SEWAGE DISPOSAL SYSTEM

MARYLAND STATE DEPARTMENT OF HEALTH

A REPAIR

SUBDIVISION ROAD 14777 Roxbury Road LOT 1

P 45702

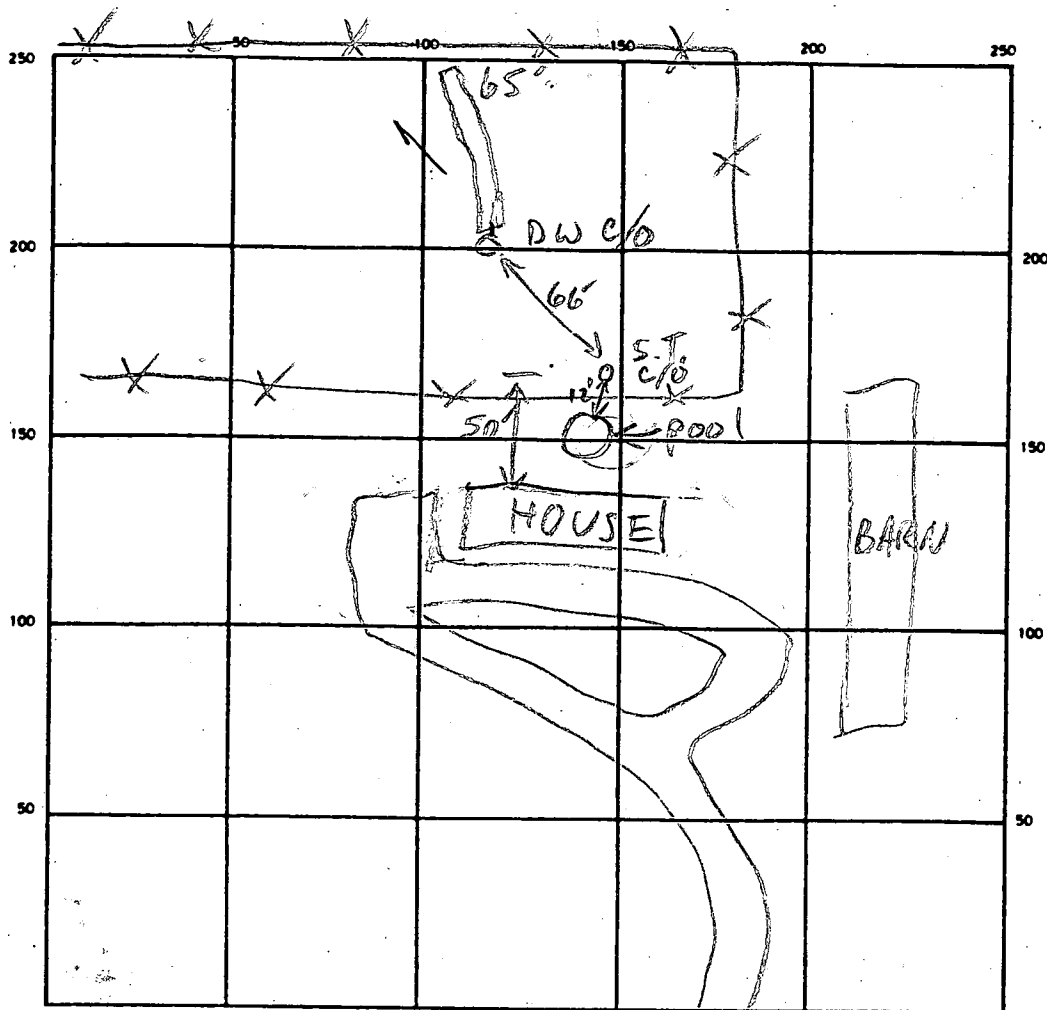
REMARKS 3/15/90 OK TO COVER WHEN READY. TRENCH GOING SLIGHTLY DOWNHILL. CONTRACTOR INDICATES THIS DUE TO OWNER'S EXCAVATION OF A "REPAIR" TRENCH OFF D/W IN SAME LOCATION. CONTRACTOR COMPENSATED BY SLOPING PIPE 1/16" / FT. MR
